DRHINAGE INFORMAL	ION SHEET
Charter Hospital Easement I'ROJECT TITLE: Modifications ZD	NE ATLAS/DRNG. FILE #: K-18 /PI
CITY ADDRESS: 5901 Zuni Road SE .	
ENGINEERING FIRM: The Mann Company, Inc.	CONTACT: Tom Mann
ADDRESS: 8200 Mountain Road NE, Suite 102	PHONE: 266-3555
CHARTER Hospital	CONTACT: Sal Tortorici
ADDRESS: 5901 Zuni Road NE	265-8800
HRCHITECT: Claudio Vigil	Claudio Vigil
ADDRESS: 825 Pennsylvania NE	265-3000 PHONE:
JRVEYOR: The Mann Company, Inc.	Tom Mann
ADDRESS: 8200 Mountain Road NE, Suite 102	266-3555 / PHONE:
LONTRACTOR: Unknown	CONTACT:
ADDRESS:	PHONE:
NONICTION E	PRB NDPC ND
DRAINAGE REPORT . XX DRAINAGE PLAN CONCEPTUAL GRADING & DRAINAGE PLAN XX GRADING PLAN ERREIDN CONTROL FLAN	SKETCH PLAT APPROVAL SKETCH PLAT APPROVAL PRELIMINARY PLAT APPROVAL SITE DEVELOPMENT PLAN APPROVAL FINAL PLAT APPROVAL BUILDING PERMIT APPROVAL FOUNDATION PERMIT APPROVAL CERTIFICATE OF OCCUPANCY APPROVAL ROUGH GRADING PERMIT APPROVAL GRADING/PAVING PERMIT APPROVAL OTHER (SPECIFY)

RE: REVISED DRAINAGE PLAN FOR A STORAGE BUILDING AT CHARTER HOSPITAL (K-18/D17) REVISION DATED DECEMBER 15, 1989

RE: DRAINAGE PLAN FOR A STORAGE BUILDING AT CHARTER HOSPITAL (K-18/D17) RECEIVED SEPTEMBER 21,

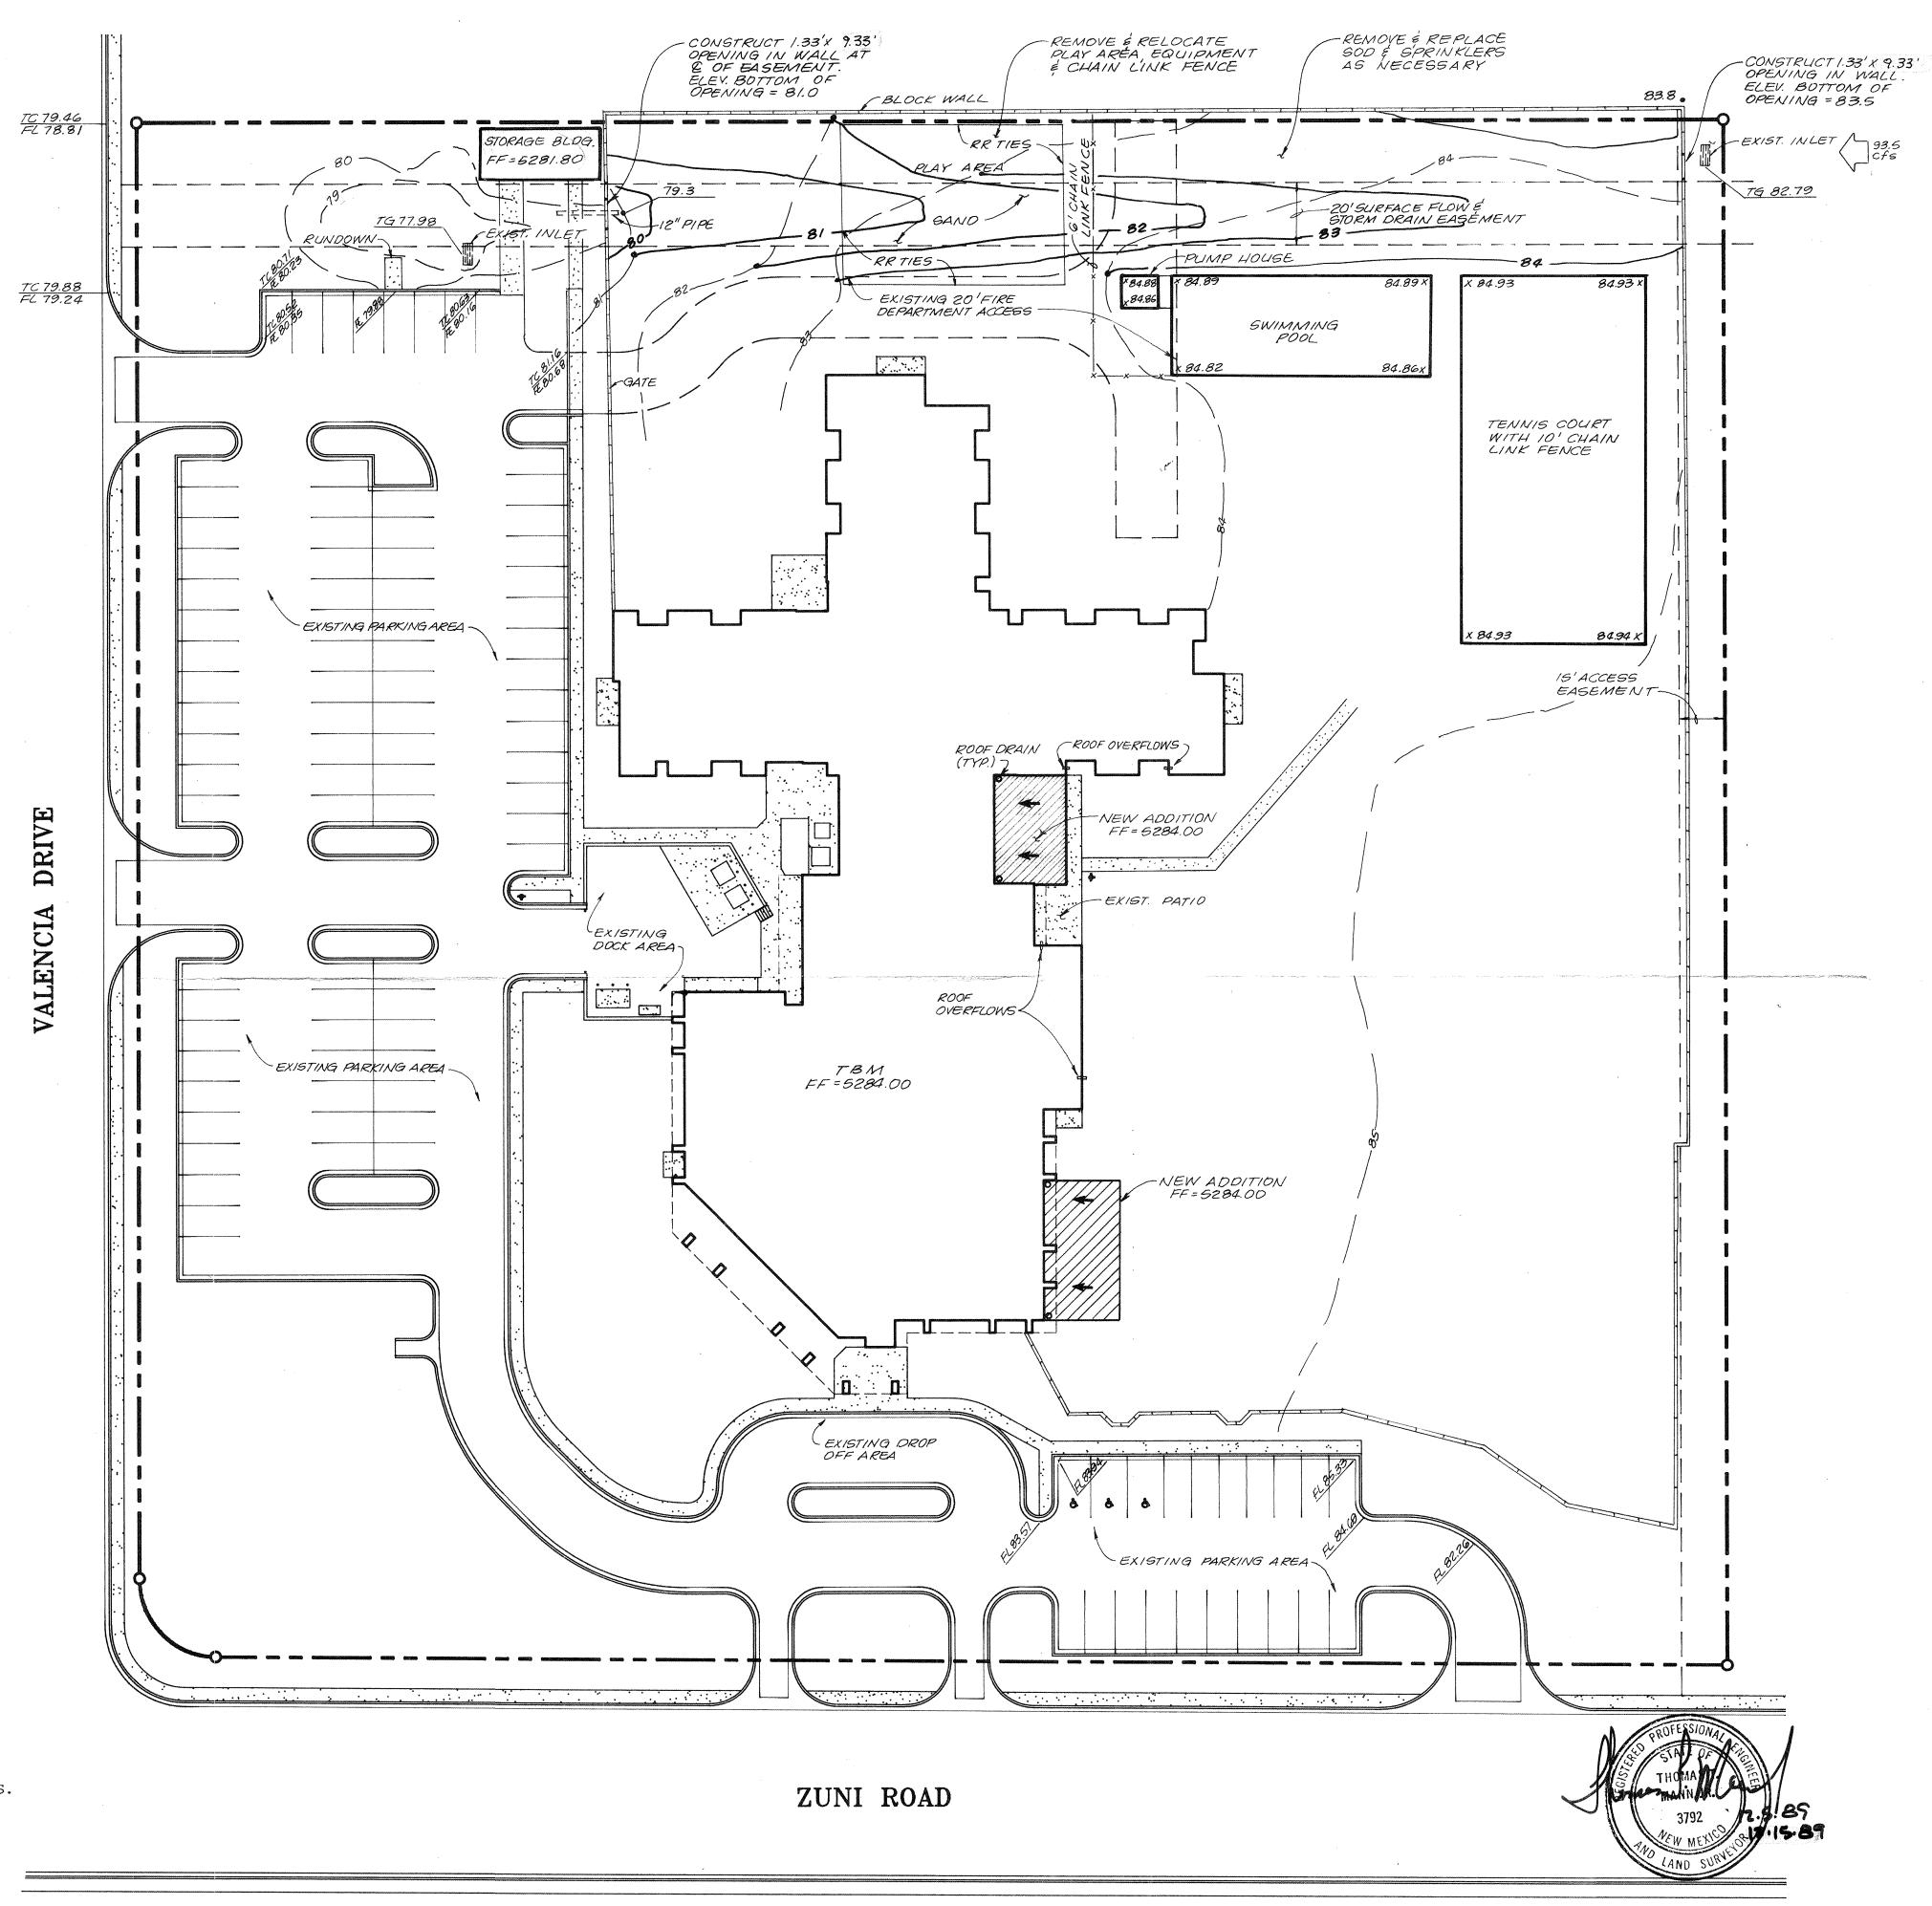
- 1. On the northeast corner of Charter Hospital, please provide information as far as contours, spot elevations, and where the existing inlet is located. Water must be kept within the easement and not allowed to meander onto private property.

- 2. You must also analyze the Q going to the inlet, the inlet capacity, and at what point the excess will spill into the easement. Your proposed 2 s.f. opening may be too large or too small. Also, keep in mind that you will need to use a clogging factor for the existing inlet. A lot of debris from the shopping center usually lands in the inlet.

- 3. Your existing contours indicate that the runoff will not stay within the easement boundaries. Swale may need to be redone so as to assure that the runoff will stay within the easement and be conveyed to your proposed 12" pipe.

- 4. Once you determine how much runoff will be entering the easement, you will also know if the proposed 12" pipe is adequate.

Originally, this plan was to indicate the modifications necessary to keep storm waters within the 20 foot drainage easement at the north end of the property. Two building additions have been added to the project. The drainage easement has been obscured by development within the easement. This plan indicates the removal and relocation of a play area, plus the construction of a grass-lined channel within the easement.

The drainage report prepared by Thomas Isaacson in April 1985, indicates that 93.5 cfs of flow is generated by the shopping center to the east. Inlet calculations indicate that approximately 50 cfs of that flow can be introduced into the storm drain. Thereby, approximately 43.5 cfs of flow will enter the site. Calculations indicate that the grass-lined channel will convey flows in excess of 43.5 cfs.

Q = (1.49/0.025) (15) (0.81) (0.105) = 76 cfs

$Q = 3.33IH^{3/2}$ $Q = (3.33)(9.33)(1.33)^{3/2} = 47.7 \text{ cfs}$
